Revision of Manuscript Number: IEEE-TPWRS-01391-2021, version 1 January 8, 2022
Journal: IEEE Transactions on Power Systems
Author: Abhishek Halder, Kenneth F. Caluya, Pegah Ojaghi, Xinbo Geng

Response to decision:

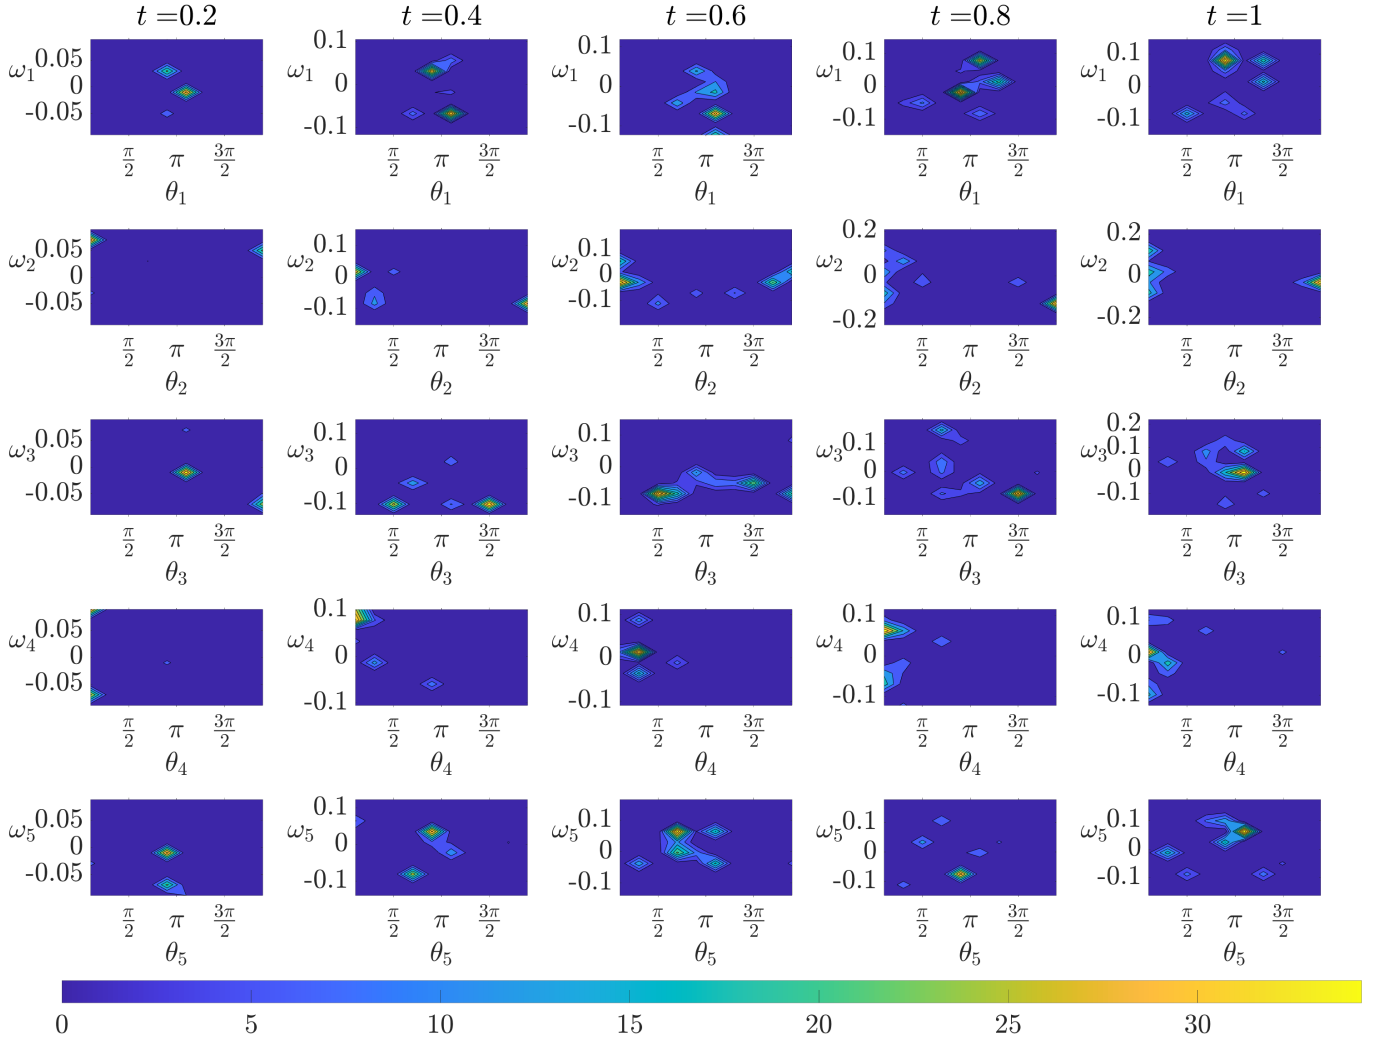
Figures 5 and 6 are unreadable.

Response: Thanks for this comment. In the previous version, the strict 10 page limit enforced small figure sizes. In the revised manuscript, Figures 5 and 6 are made larger. Also, the Fig. 6 in the revised manuscript shows the transient (θ_i, ω_i) bivariate marginals for all the five generators in Case II; the previous version showed the same only for the generator 4 (bus 6). We believe these changes have improved clarity.

Regarding the style of plots, we had considered plotting the bivariate marginals as planar contour plots (as in Fig. 1 in this rebuttal document) but decided against it because of the following two reasons.

First, in our opinion, this kind of plot is scientifically misleading as they hide the fact that these bivariate marginal PDFs are not really supported on the plane, or the subsets thereof, but instead have cylindrical supports. Our message that the proposed method explicitly accounts this manifold geometry in the computation, would be missed had we chosen to make the plots as per populist cognitive bias on behalf of the readers. That the planar plots evoke a sense of familiarity cannot be a scientific argument in favor of it.

Second, the planar contour marginal plots require additional mental efforts from the readers to correctly parse the statistical information conveyed. For instance, consider the fourth column, second row subplot in Fig. 1 in this rebuttal document. It is upon the reader to parse that the two high probability regions on the left and right of that subplot are actually referring to the same angular high probability region around $\theta_2 = 0$ rad, thanks to the periodic boundary condition on the angular variable. Our philosophy of technical communication is that the onus is on the authors, not on the readers, to clarify the scientific information as correctly as possible. And yes, we are aware that many papers in the power system literature make plots in the rectangular domain ignoring the manifold nature of the support, which in our experience, continue to add pain to the graduate students and beginning researchers trying to decipher the statistical meaning conveyed in those plots. We prefer ours not be contributing to the accrual of such pain, and instead make plots that depict the variables as they are.
